**SUBJECT:** FORTHCOMING MEETING WITH ENTERGY OPERATIONS, INC.  
(ENTERGY), ON LICENSE RENEWAL FIRE PROTECTION SCOPING  
FOR ARKANSAS NUCLEAR ONE (ANO), UNIT 1

# ANO-1 License Renewal

Fire Protection Open Item

- ◆ Open Item 2.2.3.3.2.2-1 of ANO-1 SER requested Entergy Operations provide sufficient justification for the exclusion of certain fire protection components from the scope of license renewal

# Jockey Pump

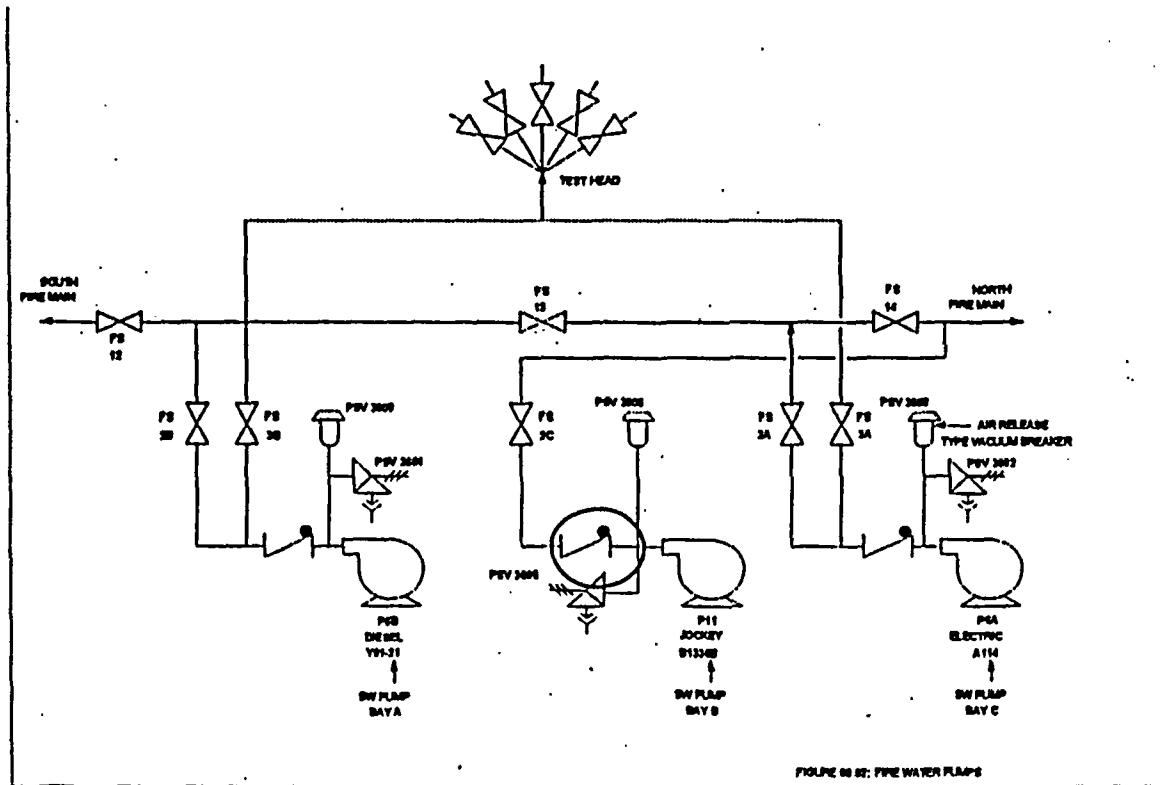
- ◆ Maintains fire main pressure when there is no demand on system
- ◆ Per BTP APSCB 9.5-1, "Details of fire pump installation should as a minimum conform to NFPA 20"
- ◆ Not a required component per NFPA 20 "Standard for the Installation of Stationary Pumps for Fire Protection"
